FIRE SAFETY INSPECTION REPORT

TIME SWEATER LTD.

ACCORD ID: 12191

May 3, 2015

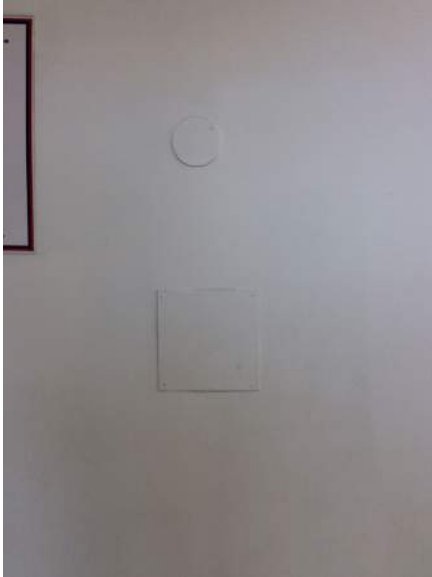
F-1	Fire Rated Construction	The exit stairs are not separated from work areas and other spaces on each floor by fire-rated construction.	Provide minimum 1.5-hr fire rated doors for buildings that are 4 or more stories. Seal all unprotected openings to separate the exit stairs from work areas and other building spaces on all floor levels. Ensure that the fire doors are self-closing and positive latching and that they are provided with fire exit (panic) hardware where serving production floors. If fire doors are required to be held open for functional reasons, provide automatic-closing devices tied to the fire alarm system. Once fire doors are installed, every door in a stair enclosure serving more than 5 stories shall be provided with re-entry unless it meets ACCORD standard 6.8.3.1.	Within 3 months
-----	-------------------------	--	---	-----------------

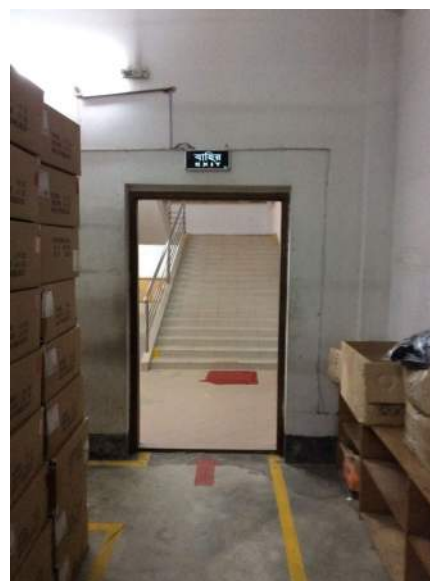
F-3	Fire Rated Construction	Unsealed penetrations and openings are located in east exit stair enclosure.	Seal all penetrations and openings in exit stair enclosure walls to maintain the fire separation.	Within 3 months
-----	-------------------------	--	---	-----------------

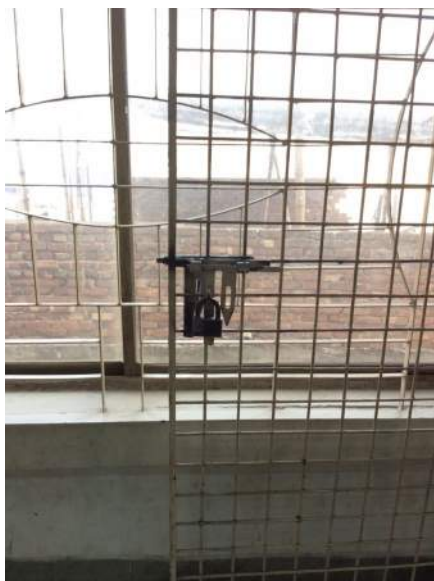
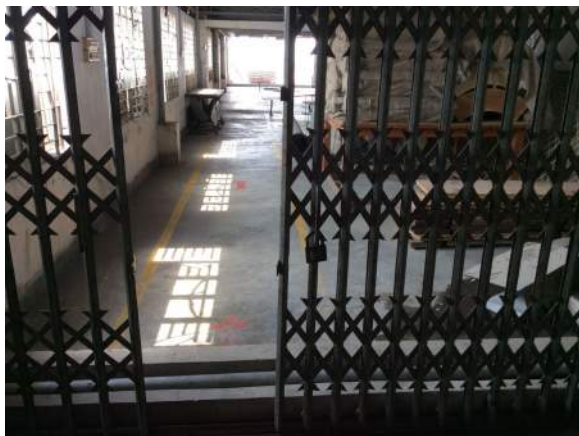
F-9	Fire Rated Construction	Rooms used for combustible storage are not separated by fire-rated construction ground, fourth, fifth floors and roof top.	Provide dedicated storage rooms separated by minimum 1-hr fire-rated construction. Where separate storage rooms are not feasible, provide defined storage areas and limit the storage arrangement as follows: - Maximum height of 2.45m (8ft.) and maximum area of 23m² (250 ft²) - If sprinkler protected: maximum height of 3.66m (12ft.) and maximum area of 93m² (305ft²) Separate areas of unenclosed combustible storage by a minimum clear distance of 3m (10ft.).	Within 3 months
-----	-------------------------	--	--	-----------------
